TECHNICAL BULLETIN
Bell Helicopter **TEXTRON**

No. 230-05-39

SUBJECT: LANDING GEAR ACTUATOR P/N 222-336-001-015, INTRODUCTION OF

HELICOPTERS AFFECTED: Model 230 helicopters serial number 23001 through 23038 equipped with retractable landing gear

Retract Actuator
Figure 1

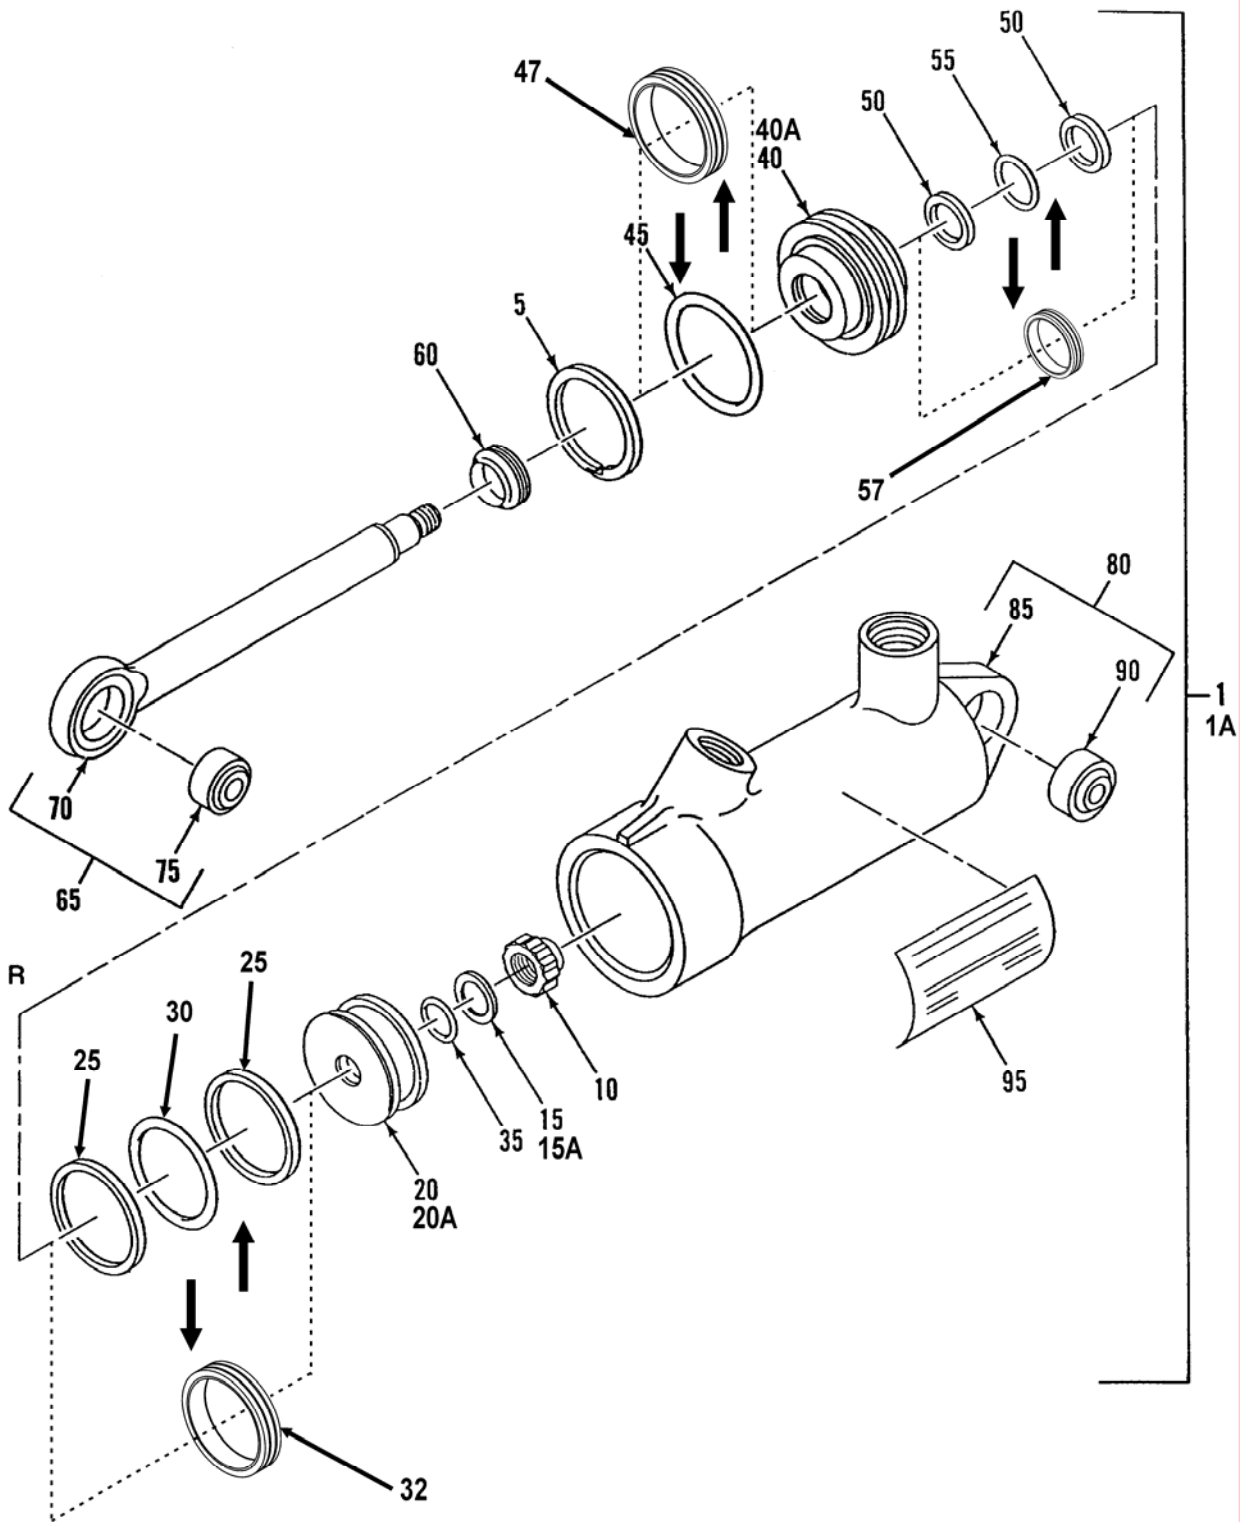
A new design actuator, interchangeable with the existing component, has been created. Improvements have been made to the dynamic seals as well as adding a friction reducing coating to the surfaces that are in contact during stroking of the actuator.

Bell Helicopter does not recommend upgrading the existing actuator to the 222-336-001-015 configuration without reworking the piston rod and the housing surfaces.

OMP3974-1 (Discard these items)	OMP3974-3 (Replace with these items)
Washer (15) Piston Head (20) Packing, Backups (25) (Qty of 2) Packing (30) Gland (40) Packing (45) Packing, Backups (50) (Qty of 2) Packing (55)	Washers (15A) (Qty of 3) Piston Head (20A) AGT Ring Seal (32) Gland (40A) AGT Ring Seal (47) AGT Ring Seal (57)

- (1) Inspect housing (85) bore ID as described in Table 801. Also, inspect for local deep wear marks near the entrance to the bore where piston head (20) made contact. If the locally concentrated depth is greater than 0.002 inches, then replace the housing. If the locally concentrated depth is between 0.0005 inches and 0.002 inches, then rework the housing as described in paragraph 5. If the locally concentrated depth is less than 0.0005 inches, then no repairs are necessary.
- (2) Inspect piston rod (70) OD as described in Table 801. Also, inspect for local deep wear marks near the threaded end of the OD where the gland (40) made contact. If there are scratches or scarring greater than 0.0005 inches deep on the .496/.498 OD, then rework the piston as described in paragraph 5. If there are no scratches, then no repairs are necessary.

- (1) Machine the housing bore ID to a maximum diameter of 1.434 inches.
- (2) Electrolyze the bore ID per MIL-DTL-23422, AMS2406 or AMS2438.
- (3) Finish dimensions to original manufacturing limits described in Table 801 and maintain surface finish of 16 rms or better.

- (1) Machine the rod OD to a minimum diameter of 0.488 inches to remove chrome plating.
- (2) Chrome plate the rod OD per AMS-QQ-C-320 (hard chrome).
- (3) Finish dimensions to original manufacturing limits described in Table 801 and maintain a surface finish of 16 rms or better.
